in the matter of: notices of requirement and resource consent applications by the NZ Transport Agency and Hamilton City Council for the Southern Links Project

Rebuttal evidence of Adrian Morton (Landscape Visual and Urban Design)
on behalf of the **NZ Transport Agency and Hamilton City Council**

Dated: 8 July 2014

ANNEXURE A
REVISED CONCEPT LANDSCAPE PLAN
 Drawing No. 2316305-E-20-2002 Rev C

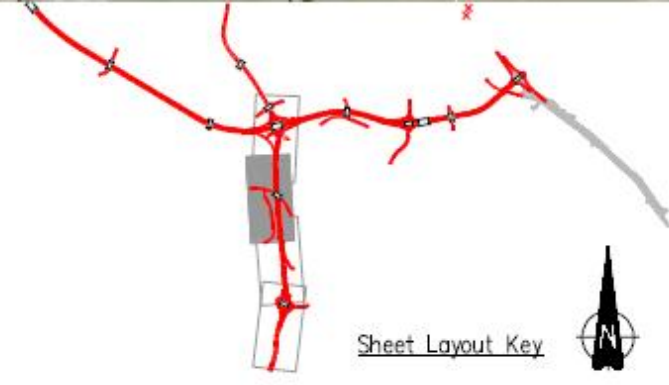
- 7 In paragraph 5.2 of Mr Inger's evidence, he states that the Concept Landscape Plan (CLP) relevant to the Ingrams' property has not been updated to reflect the discussion and information provided in paragraph 130 of my EIC. In paragraph 5.5, Mr Inger requests that this CLP be updated.

- 8 The CLP Drawing No. 2316305-E-20-2002 Rev C for the Ohaupo Road location has now been updated, and is attached as **Annexure A** to my rebuttal evidence.

- 9 The amended CLP illustrates the proposed replacement hedge location, the adjustment of the embankment to avoid the pond and the retention of the existing trees. Additionally, the designation boundary has been reduced with it being adjusted west to avoid the pond, to provide certainty to the submitter in relation to their concerns in retaining these features.¹
